Access Compliance Report Public Rights-of-Way (Curb Ramps)

Main Street: N/A		Cross Street: IRVINE_BLV		Location:	SW
ADA ID: RPAT211027105841	Ramp Type:Type 1 - Perpendicular	Initial Pass/Fail: Fail	Overall Compliance: No	Severity Score:	15
Codes/Mitigation Info/Possible Solution			Field Measurements/Component Compliance

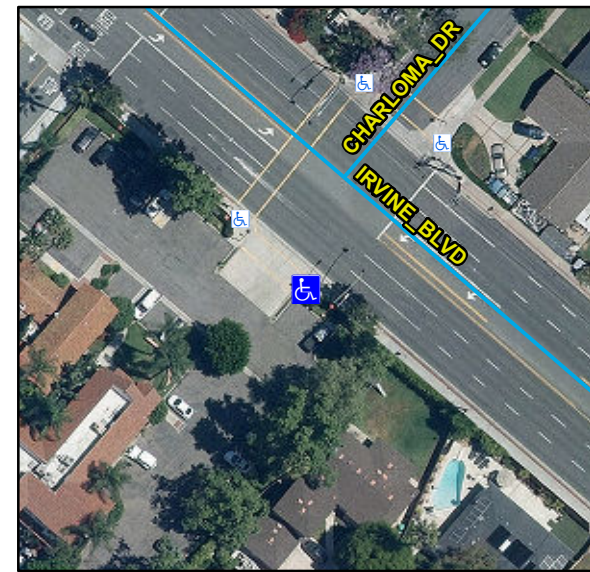
Compliance	Description	Data	Compliance	Description	Data
N/A	Ramp Length (in)	87	N/A	Flare Type LT	
Yes	Ramp Width (in)	48			N/A
No	Ramp Run Slope (%)	8.9	N/A	Flare Slope LT (%)	N/A
Yes	Ramp Cross Slope (%)	0.7	N/A	Flare Traversable LT	N/A
N/A	Landing Present	N/A	N/A	Flare Type RT	
N/A	Landing Length (in)	N/A			N/A
N/A	Landing Width (in)	N/A	N/A	Flare Slope RT (%)	N/A
N/A	Landing Run Slope (%)	N/A	N/A	Flare Traversable RT	N/A
N/A	Landing Cross Slope (%)	N/A	N/A	DWS Provided	N/A
N/A	Landing Movement Obstructed?	N/A	N/A	DWS Contrast	N/A
	Landing Movement Type	N/A	N/A	DWS Length (in)	N/A
N/A	Landing Shared	N/A	N/A	DWS Full Width	N/A
N/A	Clear Space	N/A	N/A	DWS Offset Left (in)	N/A
N/A	Clear Space To Crosswalk (in)	N/A	N/A	DWS Offset Right (in)	N/A
N/A	Marked Crosswalk 1	Yes	N/A	Marked Crosswalk 2	N/A
	Crossing 1 Direction	NW		Crossing 2 Direction	N/A
	Marked Crosswalk 1 Width (in)	120		Marked Crosswalk 2 Width (in)	N/A

N/A	Ramp Inside Crosswalk 1	Yes	Yes	Ramp Inside Crosswalk 2	N/A
	Crossing 1 Slope (%)	0.4		Crossing 2 Slope (%)	N/A
	Crossing 1 Cross Slope (%)	4.1		Crossing 2 Cross Slope (%)	N/A
N/A	Gutter Ponding	N/A	No	Curb Slope	7.3
Yes	Gutter Lip Height (in)	0		Road Run Slope (%)	N/A
N/A	Gutter Run Slope (%)	N/A		Road Cross Slope (%)	N/A
N/A	Gutter Cross Slope (%)	N/A			
Yes	Overall Surface Condition: Acceptable		Yes	Perp Joint Present	Yes
	Cross Gutter Present?	Yes		Spandrel Present?	Yes
	Replace Cross Gutter?	No		Replace Spandrel?	No

Remove & Replace Entire Ramp.

R304.2.2, STD 1115
